CITY OF FREDERICKSBURG HISTORIC REVIEW BOARD

TUESDAY, DECEMBER 13, 2022

**Historic Review Board
Application Information**

Application Number: 22-111
Date: December 13, 2022
Address: 408 N Milam
Zoning: C1
Owner: Reuben Bohnert
Applicant: William Whitworth
Rating: Landmark
Proposal: new storage/outbuilding

408 N. Milam St.

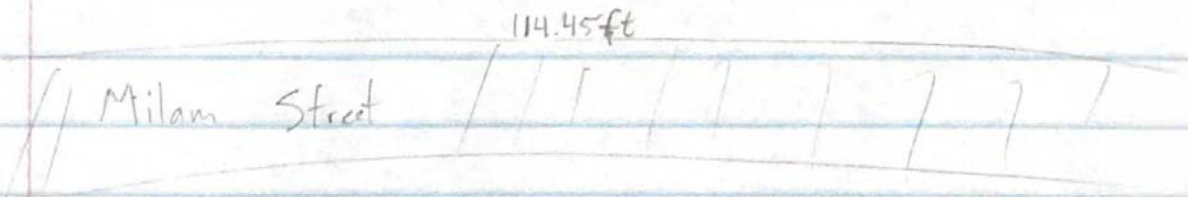
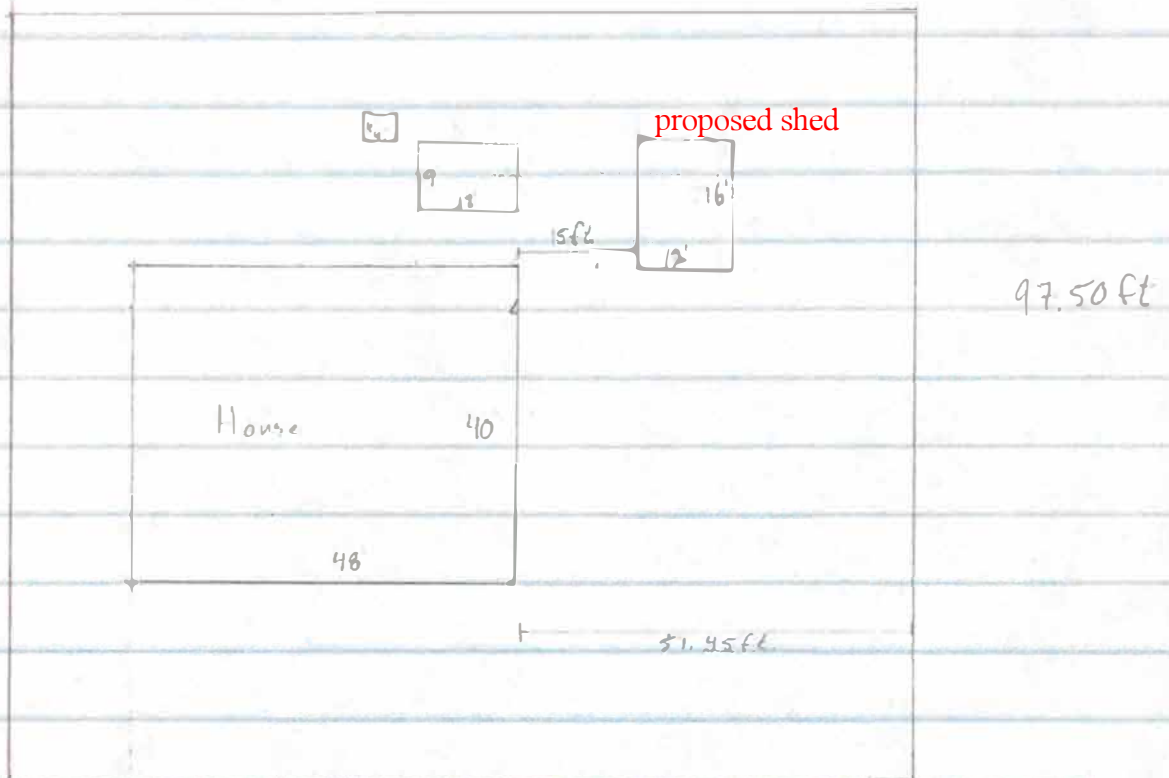
- A. The proposed storage/outbuilding is appropriate in materials and height. (3.4.1.g)
Given the shape of the property it is not feasible to place it behind the main structure which would lessen the visibility of the outbuilding. Staff recommends approval. Staff will review final color selection.

SITE/ROOF PLAN

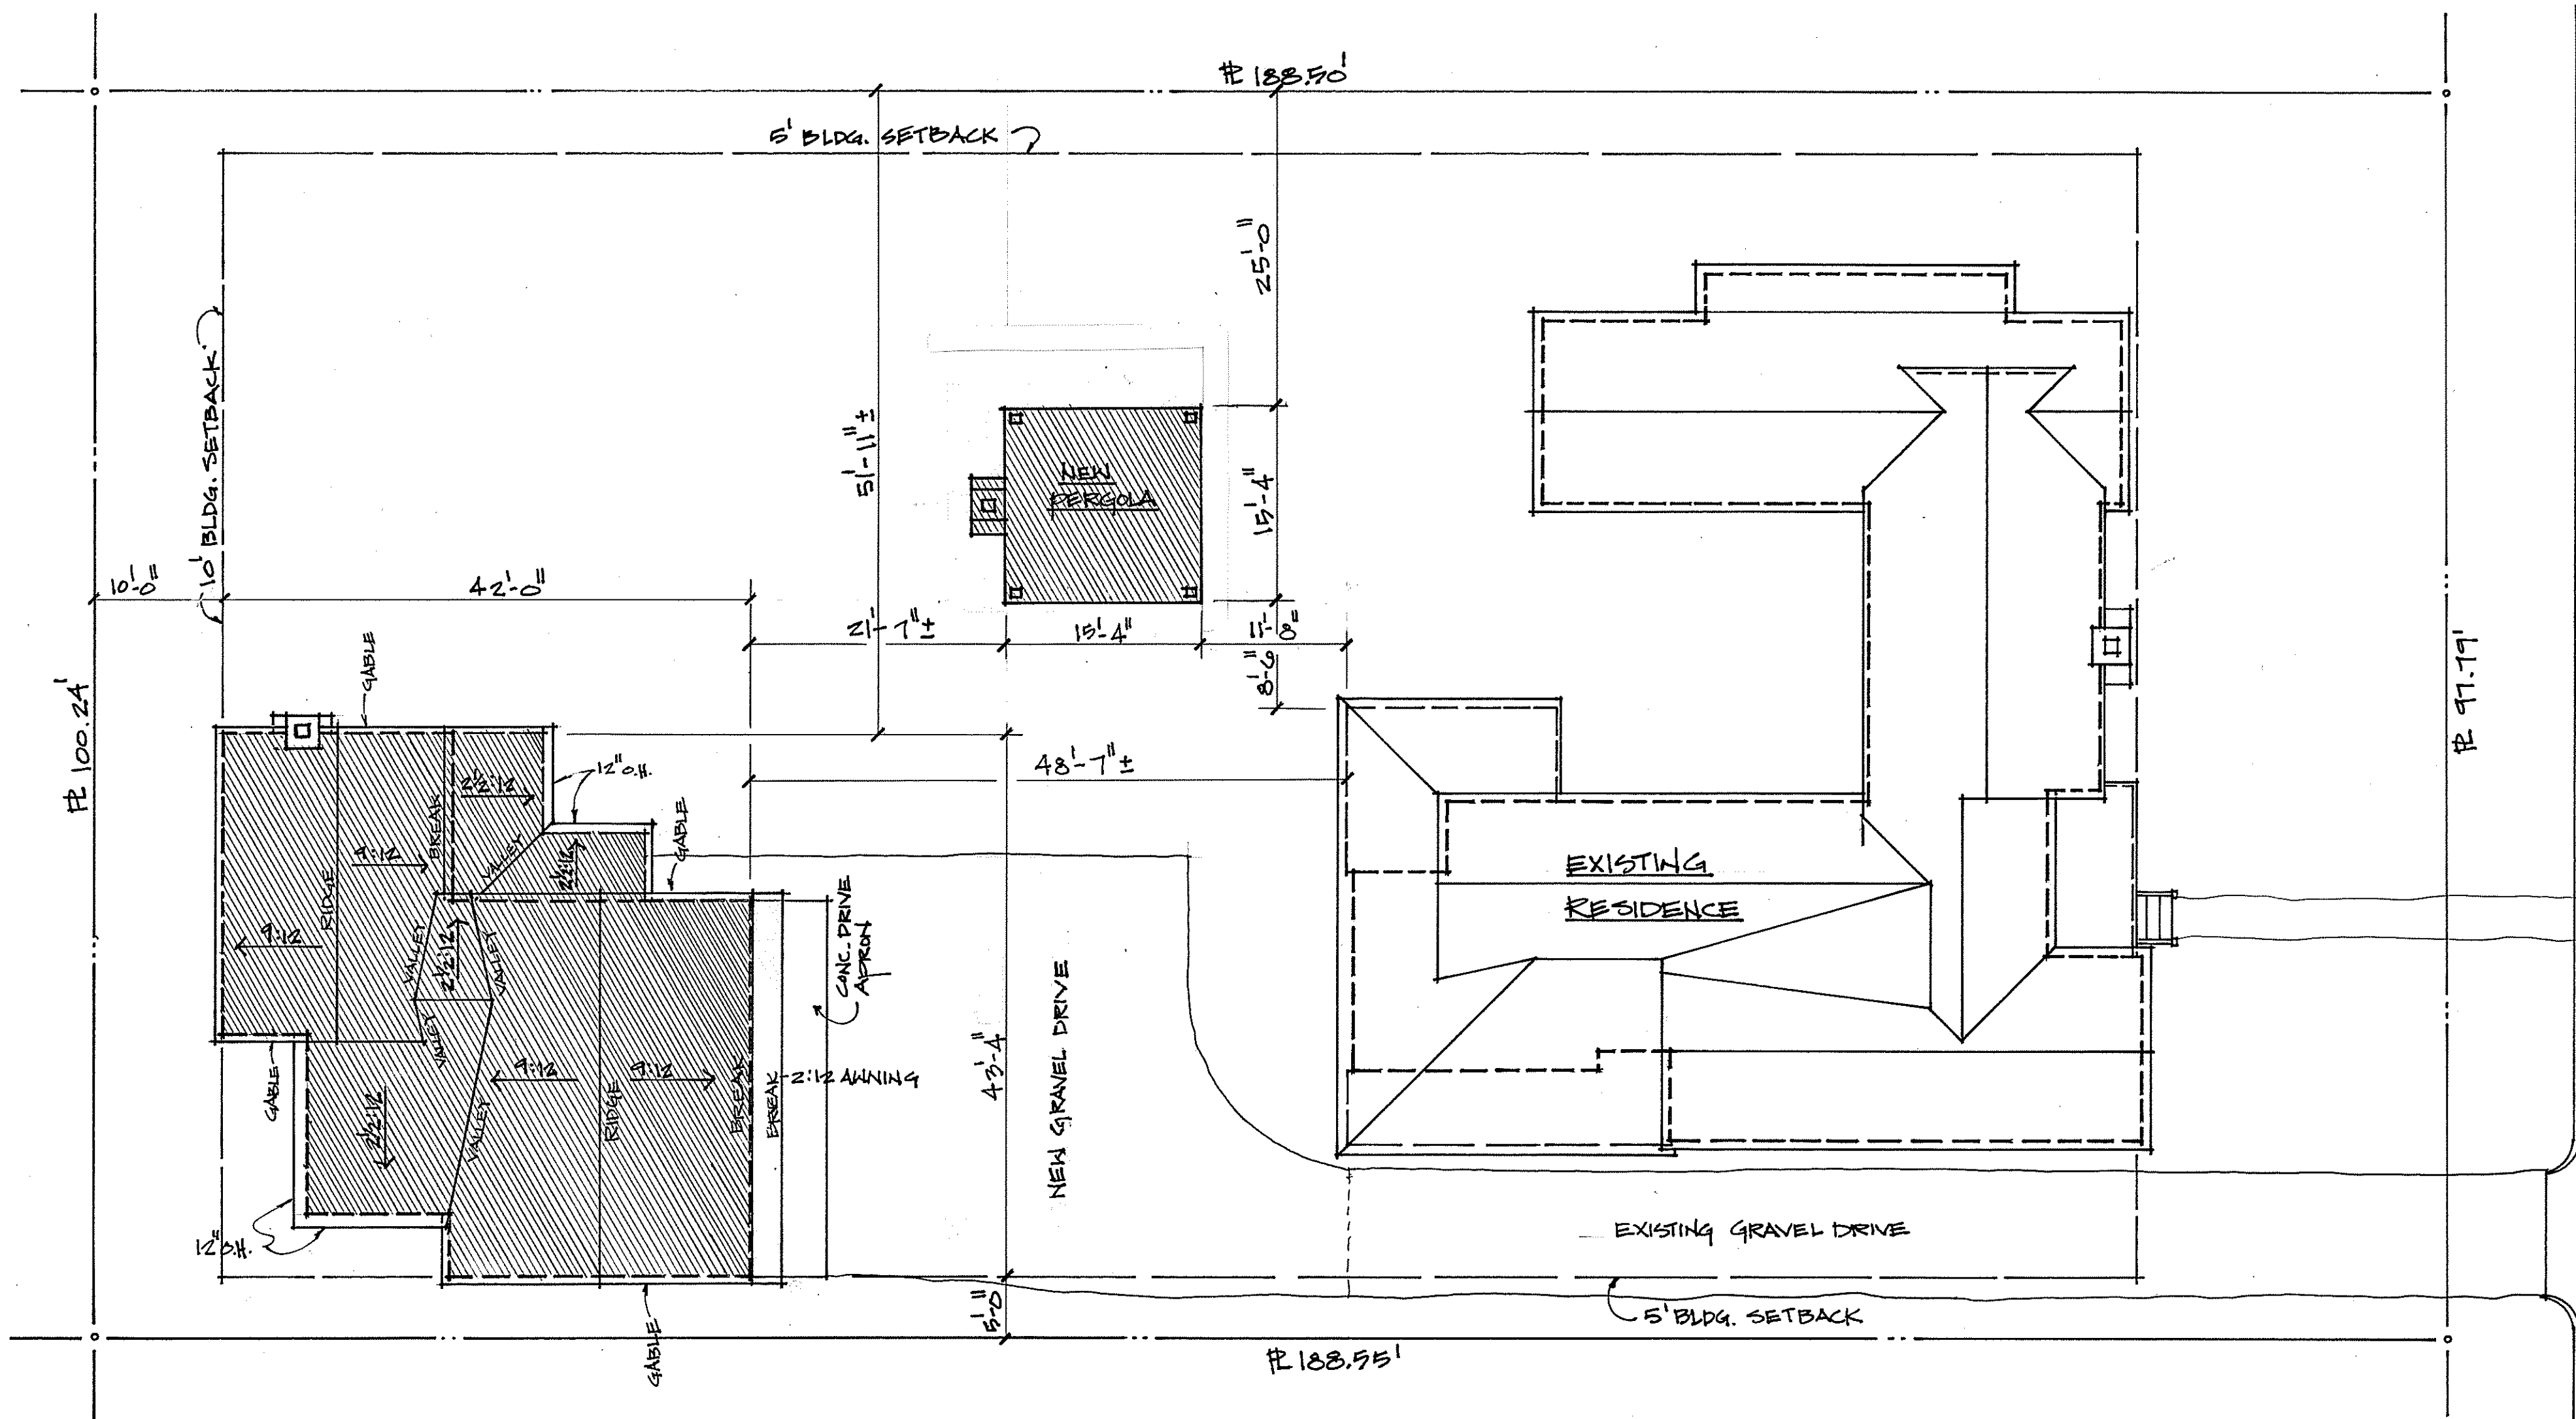
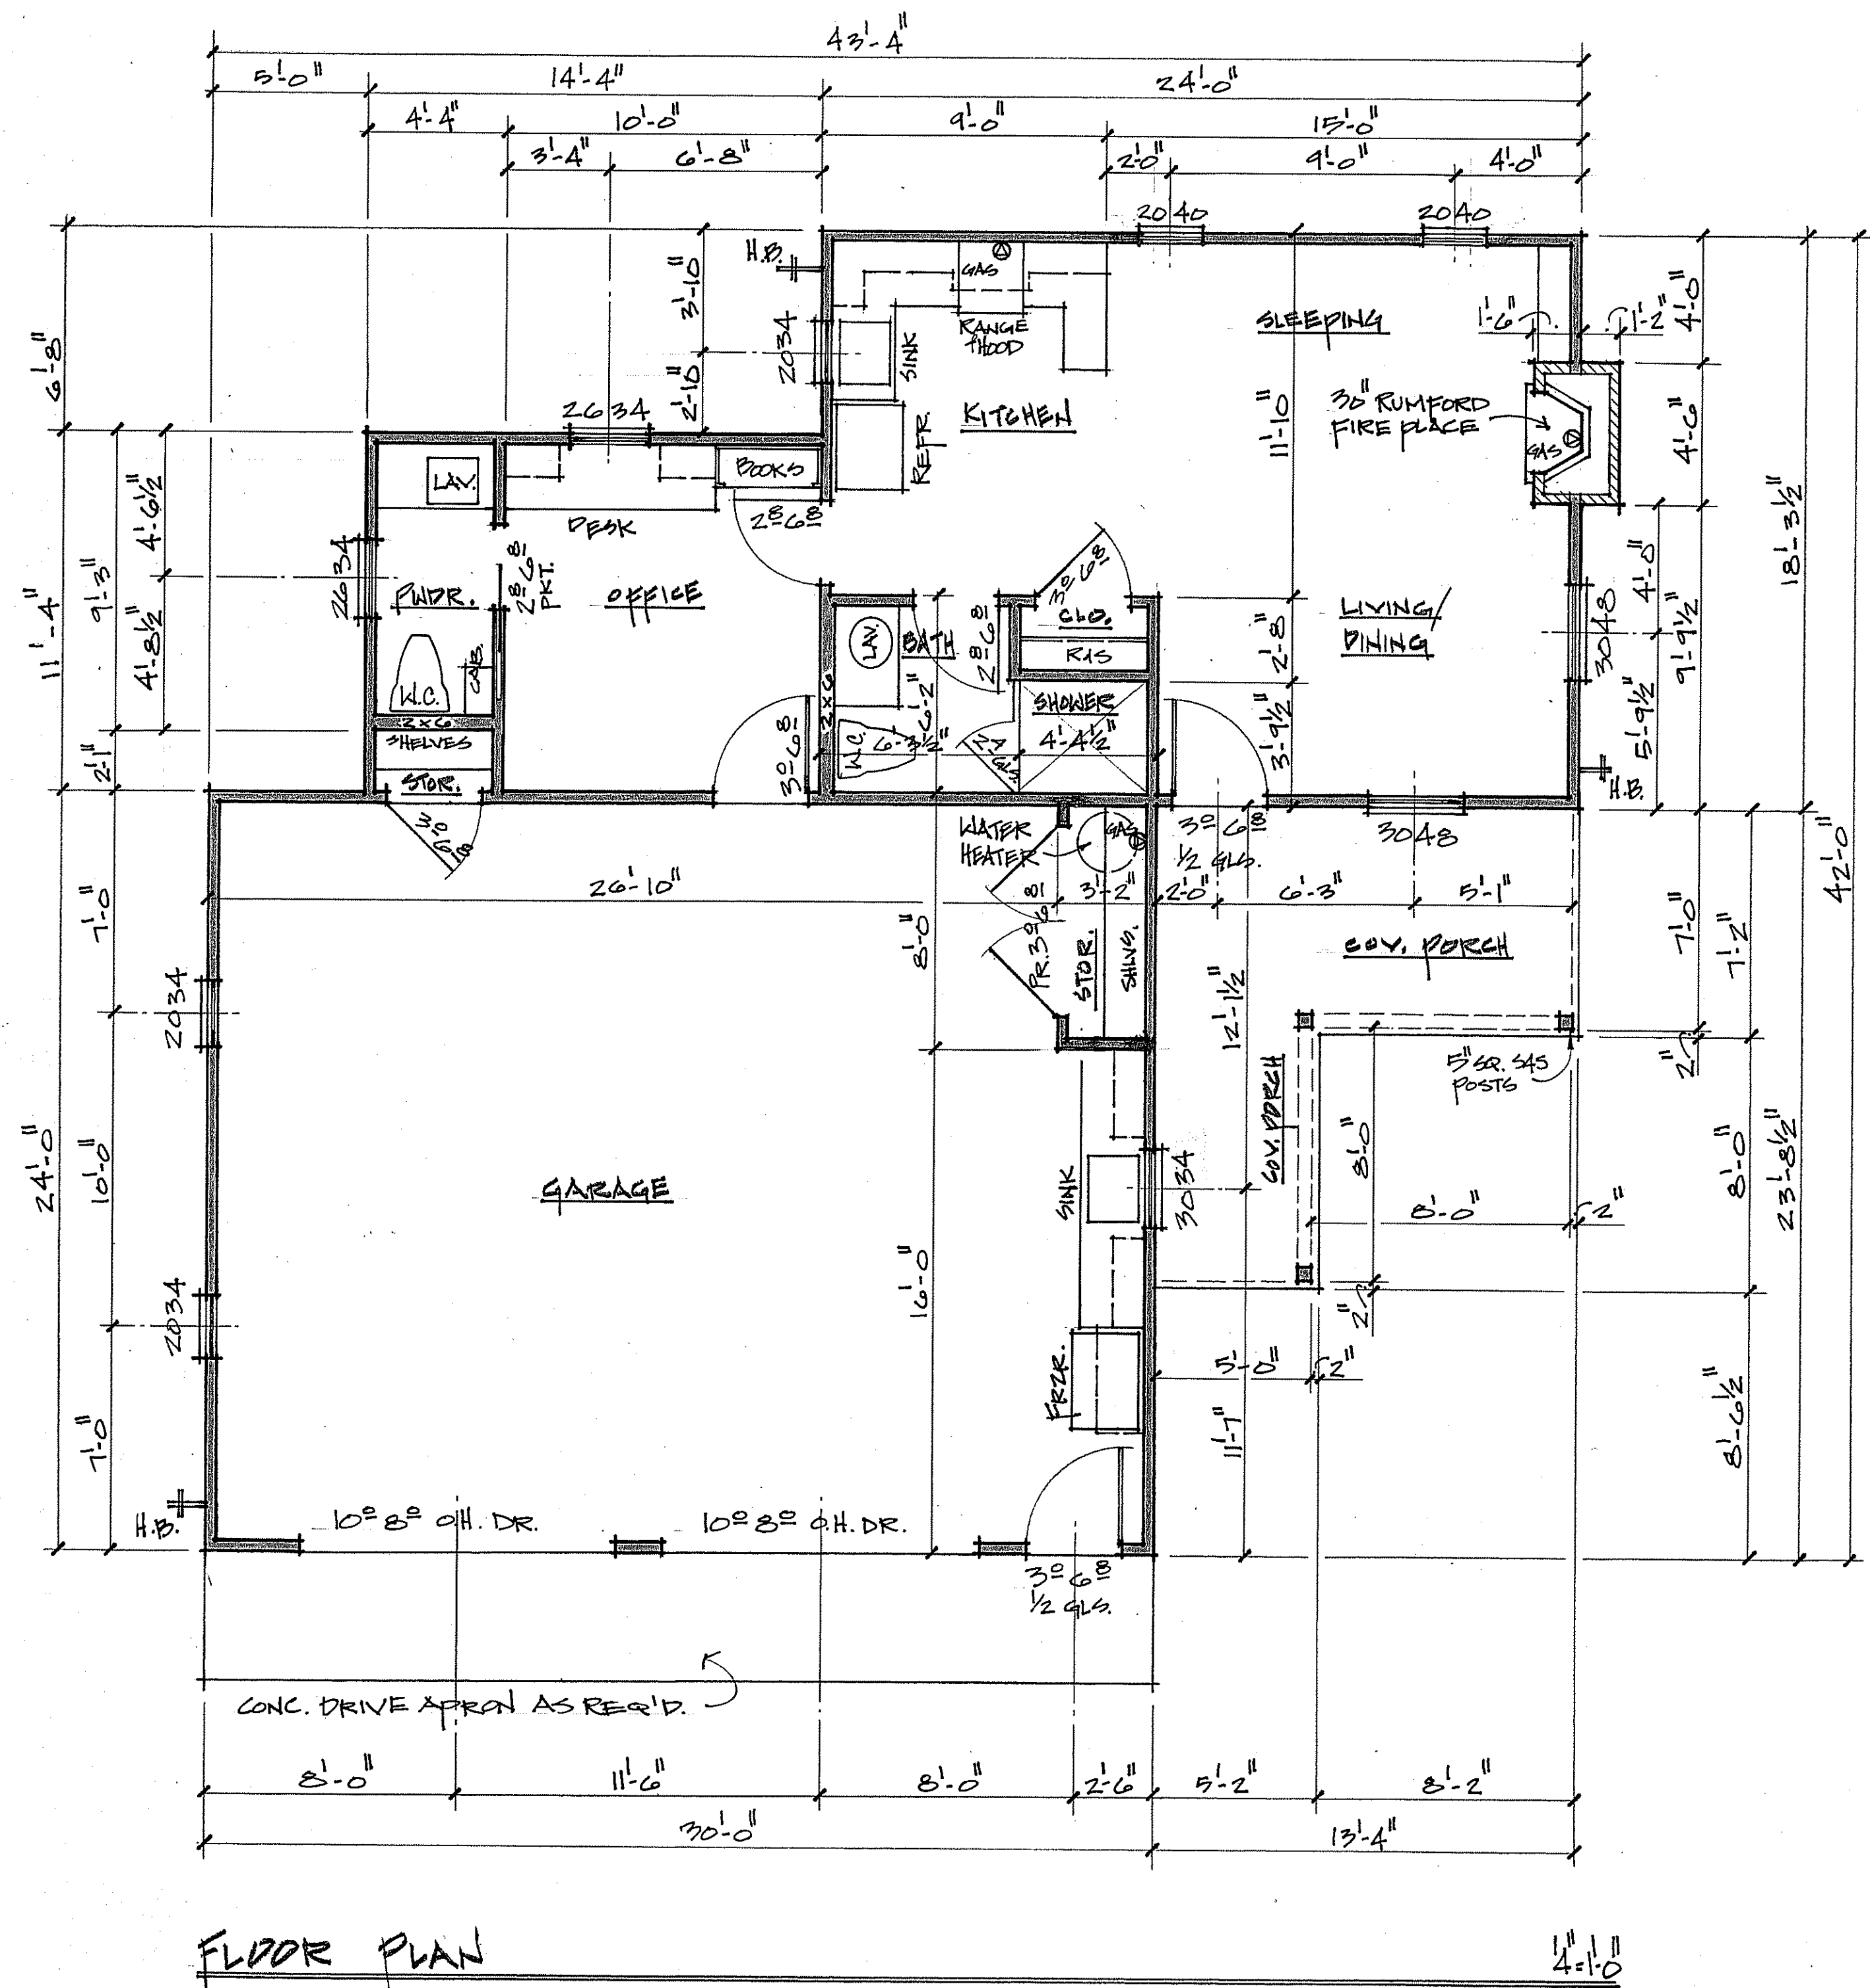
The materials and style of the new structure are in keeping with the Design Guidelines.

The size of the proposed new auxiliary structure is less than 50% of the main house square footage. (3.4.1.h)

The footprint of the new garage measure 720 sq f.ADU is less than the footprint of the main house.

The ADU will not be readily visible from the street. Staff recommends approval based on referenced Design Guidelines and Standards.

VIEW OF SOUTHEAST CORNER OF HISTORIC HOUSE

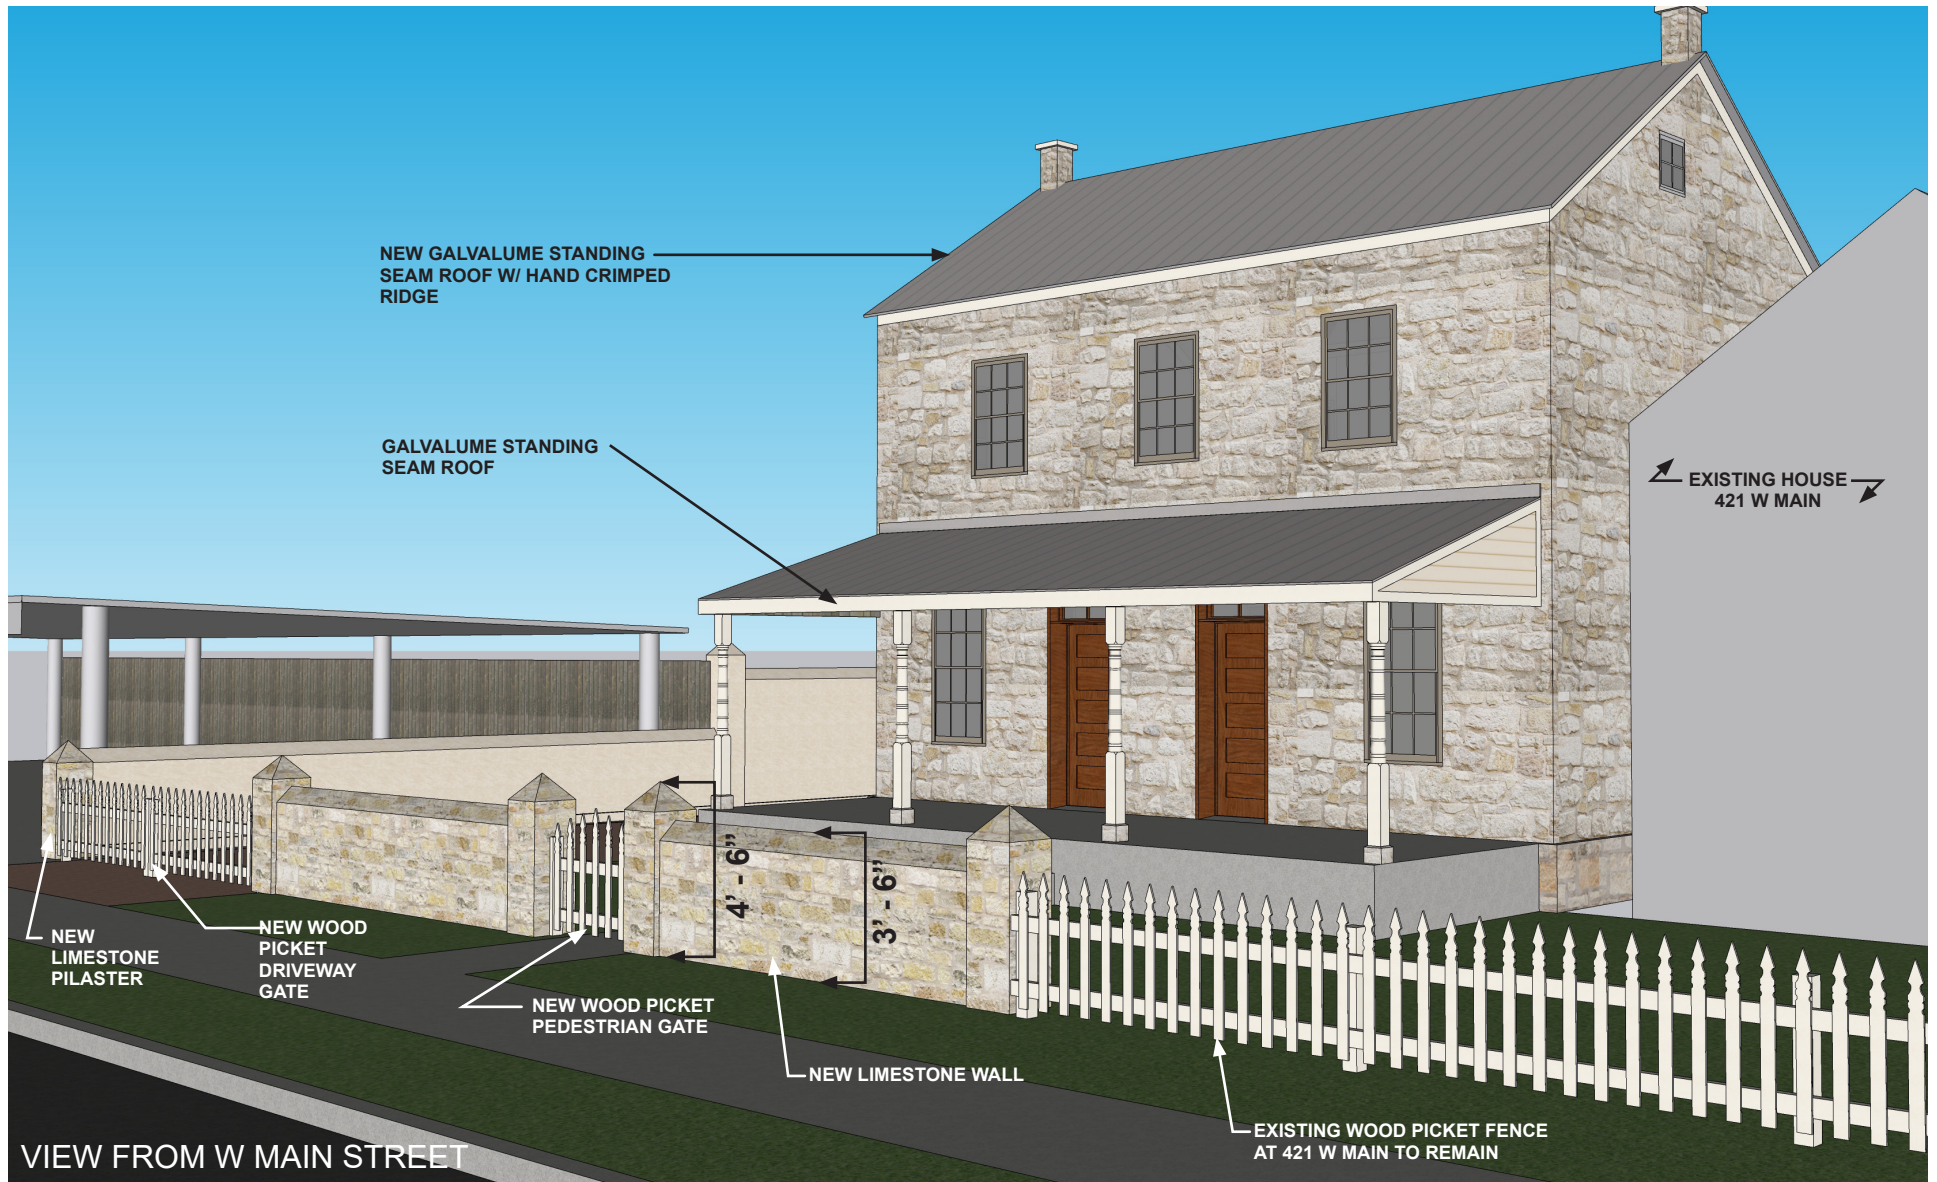
- C. Interior alterations trigger the requiemnt for safety glass given the proximity of the window to a new stair. The window is not visible from the street and only the glass will be replaced. Staff recommends approval as requested. 3.2.8.(c)
